**Tillbridge Solar Project  
EN010142**

**Volume 9  
Statement of Common Ground with Trent Valley  
Internal Drainage Board**

**Document Reference: EN010142/APP/9.14**

**October 2024  
Revision Number: 00**

Figure 1: Trent Valley Internal Drainage Board Crossings

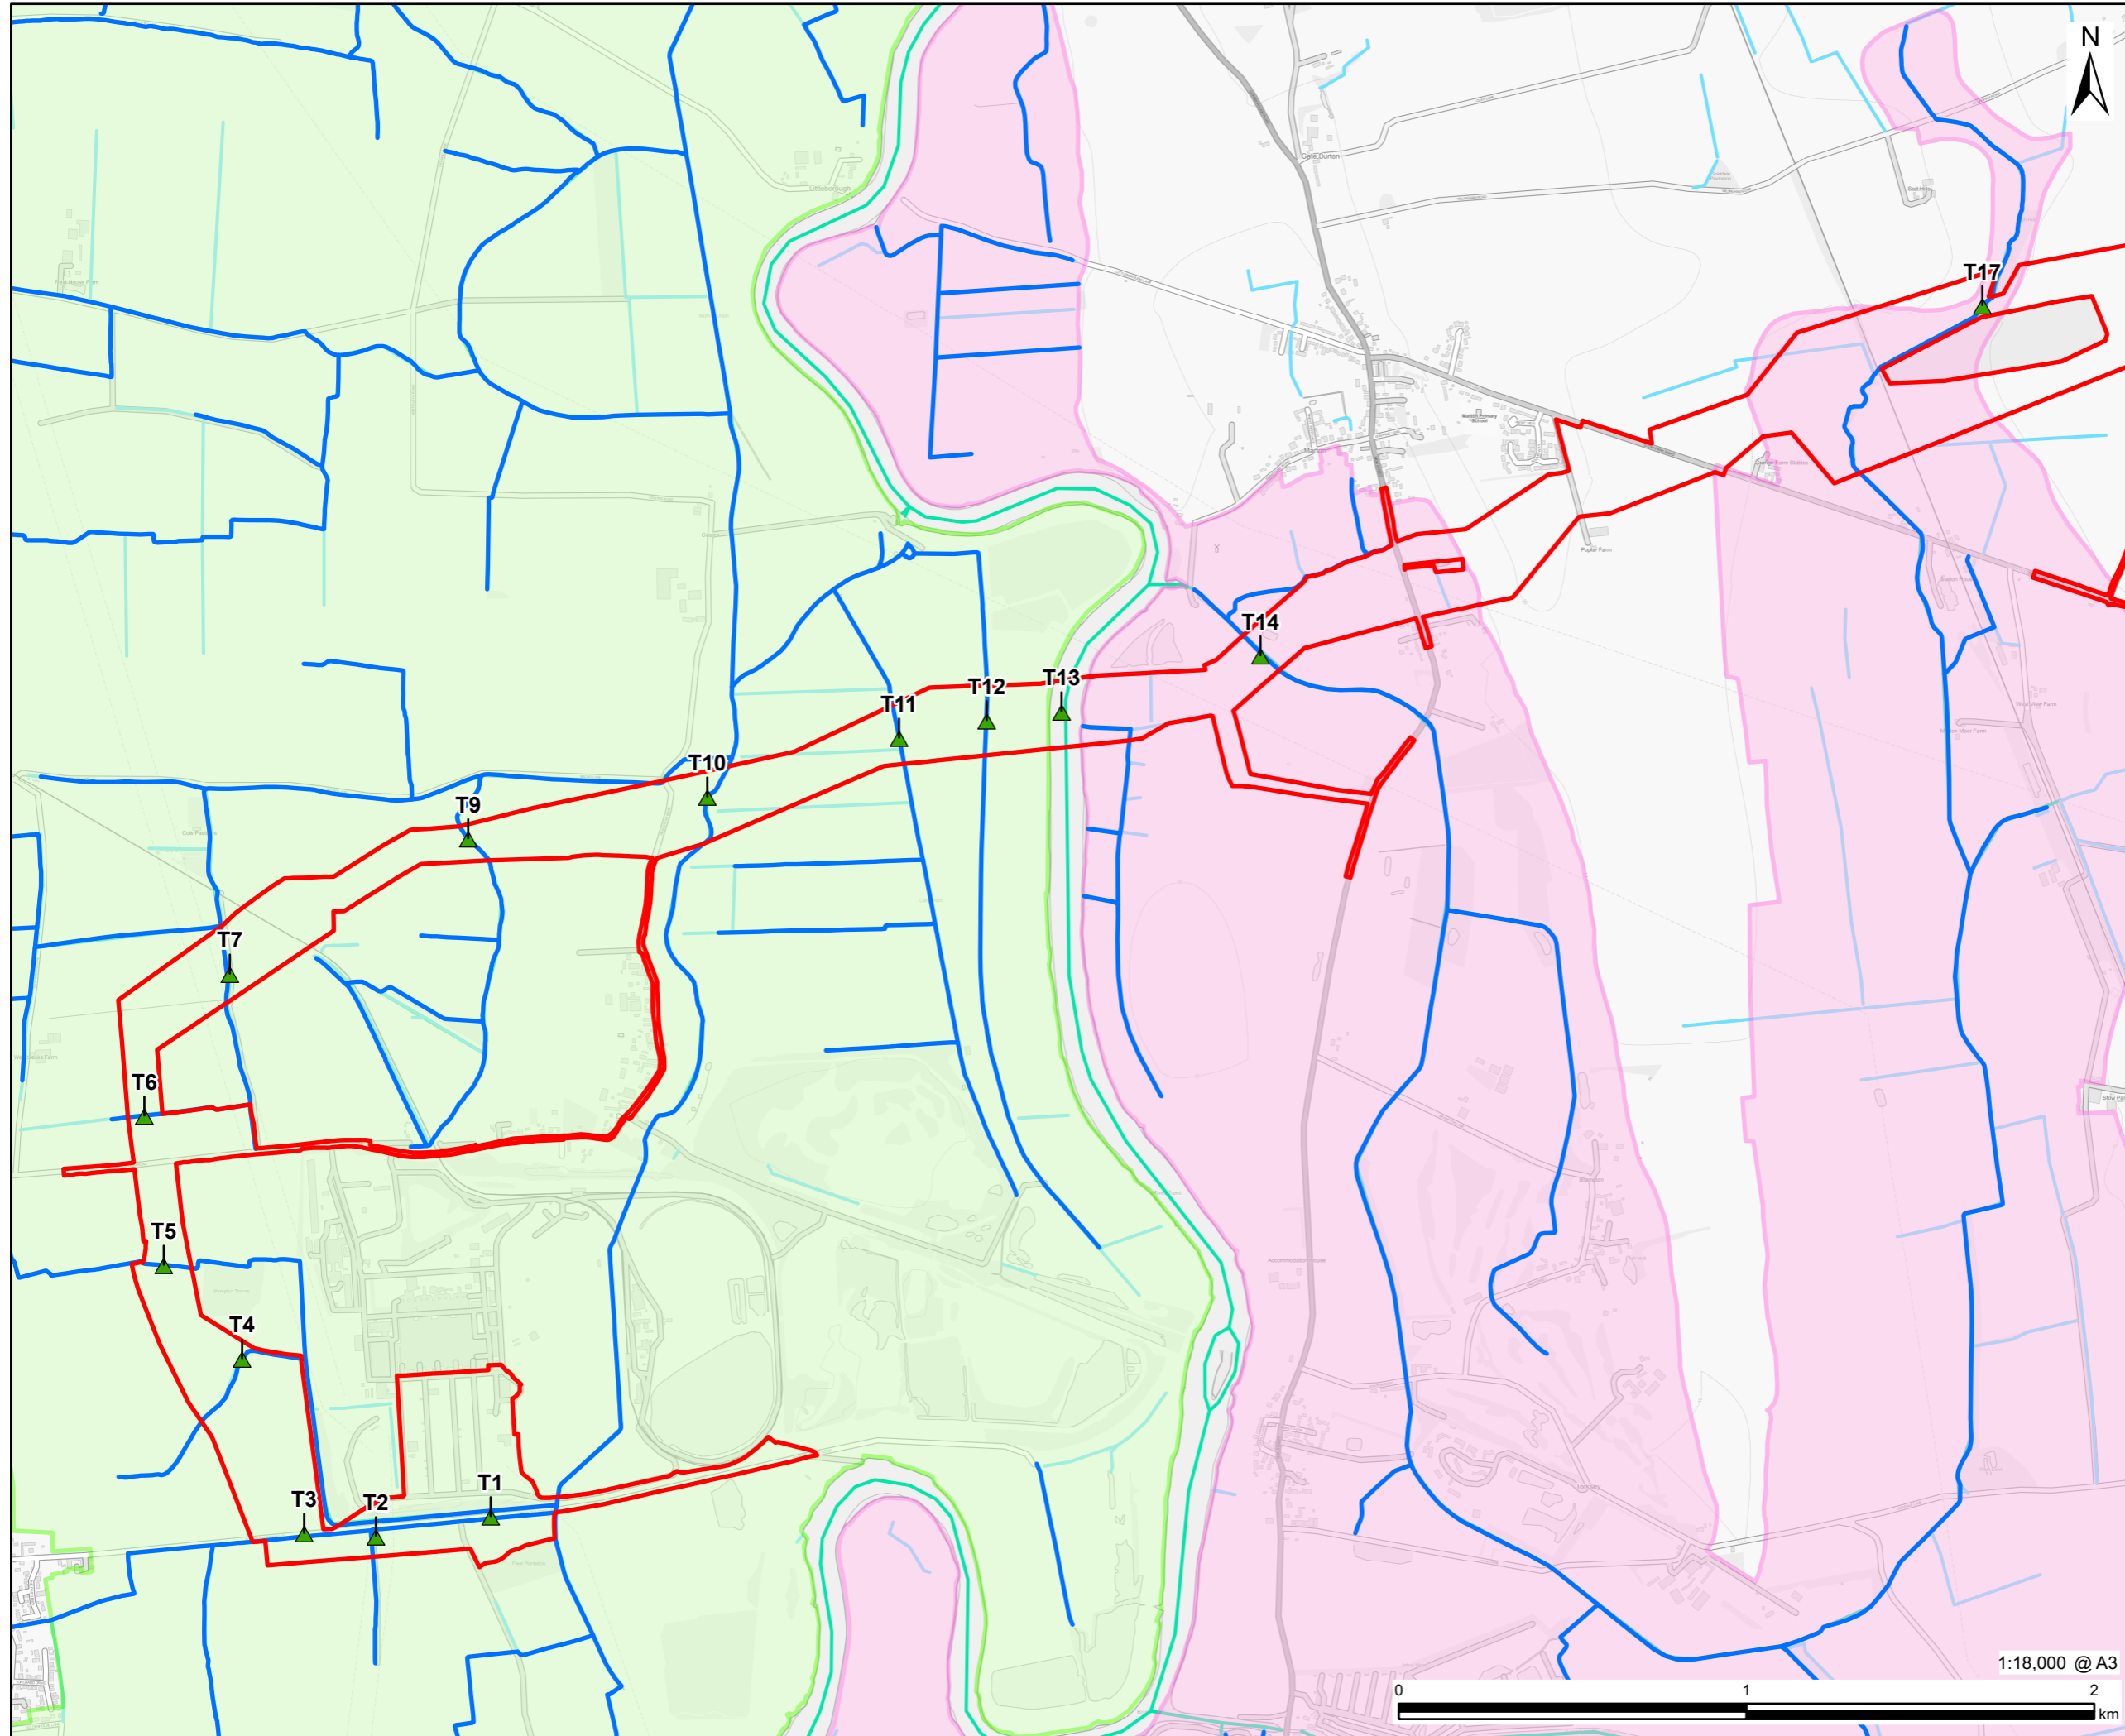
Ref.	Relevant Application Document	Description of Matter	Status	Likelihood of Resolution
<b>Additional Consultation September 2023</b>				
1.1	<b>Chapter 10: Water Environment of the ES [EN010142/APP/6.1(Rev01)]</b>	<p><b><u>TVIDB’s Comment:</u></b>  All Channels in TVIDB to be crossed using trenchless (non-intrusive) techniques.</p> <p><b><u>Applicant’s Response:</u></b>  This has been included within the Scheme design.</p> <p>This is stated within Section 10.7 Embedded Design Mitigation of <b>Chapter 10: Water Environment</b> of the ES <b>[EN010142/APP/6.1(Rev01)]</b>, set out within the <b>Framework CEMP [EN010142/APP/7.8 (Rev01)]</b> and the location of the crossings is illustrated by <b>Figure 1</b> within <b>Appendix A</b> of this SoCG.</p>	Agreed – TVIDB comment has been resolved.	Resolved
